# UNITED STATES PATENT AND TRADEMARK OFFICE

APPLICATION NO.	FILING DATE	FIRST NAMED INVENTOR	ATTORNEY DOCKET NO.	CONFIRMATION NO.
10/821,628	04/09/2004	Helmut Harrer	12484/3	8931
757 7590 01/03/2007 BRINKS HOFER GILSON & LIONE P.O. BOX 10395 CHICAGO, IL 60610			EXAMINER GUADALUPE, YARITZA	
			ART UNIT	PAPER NUMBER
			2859

<b>Office Action Summary</b>	<b>Application No.</b> 10/821,628	<b>Applicant(s)</b> HARRER, HELMUT	
	<b>Examiner</b> Yaritza Guadalupe McCall	<b>Art Unit</b> 2859

## DETAILED ACTION

FIG. 6

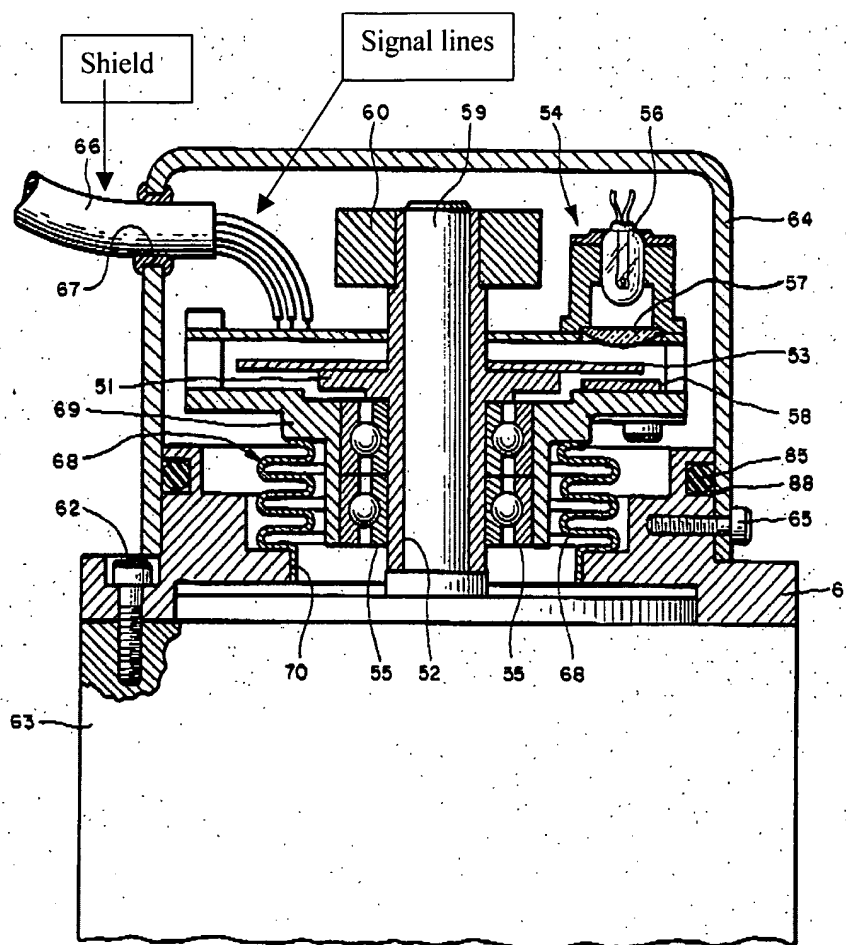
With respect to claim 1, Ernst discloses a position measuring system ( See Figure 6 ), comprising a housing ( 64 ) comprising a wall, said wall having an opening ( 67 ) and comprising a deformation ( note how the opening shows an alteration to its form and shape ); a measurement device ( See Column 5, lines 36 - 48 ) accommodated in said housing ( See Figure 6 ), said measurement device detecting and processing measurement values and outputs a position-dependent measurement signal; a cable ( 66 ) comprising what could be considered a shield ( as suggested from Figure 6 where it is shown a shield covering three signal lines that are attached to the measurement device ) around signal lines ( See Figure below ), wherein said cable is positioned within said opening and said signal lines are electrically connected to said

measurement device so as to carry said measurement signal; and wherein said deformation of said wall fixes said cable in said opening and for binding said shield to said housing so as to provide a secure electrical contact between said shield and said housing.

Ernst does not disclose the particular shield being specific for preventing electromagnetic interference as stated in claim 1. Ernst does not disclose the deformation being integral as stated in claim 1. Ernst does not disclose the adhesive or ply as stated in claims 6 and 7.

Regarding the shield as now recited in claim 1: Ernst discloses a shielded cable ( as shown in Figure 6 above ) but fails to specify whether it protects from electromagnetic interference as claimed. Diep teaches an assembly comprising a cable bundle ( 22, 28 ) provided with a shield ( 30 ) and an insulator/outer jacket ( 32 ) that protects from electromagnetic interference (EMI) to ensure reliable data transmission over the cables ( See Column 2, lines 40 – 46 ). Therefore, it would have been obvious to a person having ordinary skill in the art at the time the invention was made to replace the shield provided by Ernst, with a shield that protects from electromagnetic interference (EMI) as taught by Diep, in order to ensure reliable data transmission over the cables ( See Column 2, lines 40 – 46 of Diep ).

With regards to claims 6 and 7 : Ernst discloses a housing ( 64 ) having an opening ( 67 ) provided with a material ( as suggested from figure 6 ), however, the particular material being used has not being disclosed. The particular type of material used to fixedly attach said cable in said opening, absent any criticality, is only considered to be the use of a “ preferred ” or “ optimum ” material out of a plurality of well known materials that a person having ordinary skill

With respect to claim 11, Ernst teaches a position measuring system wherein said end wall, in a region of said opening, has a swelling of material ( See Figure 6 ).
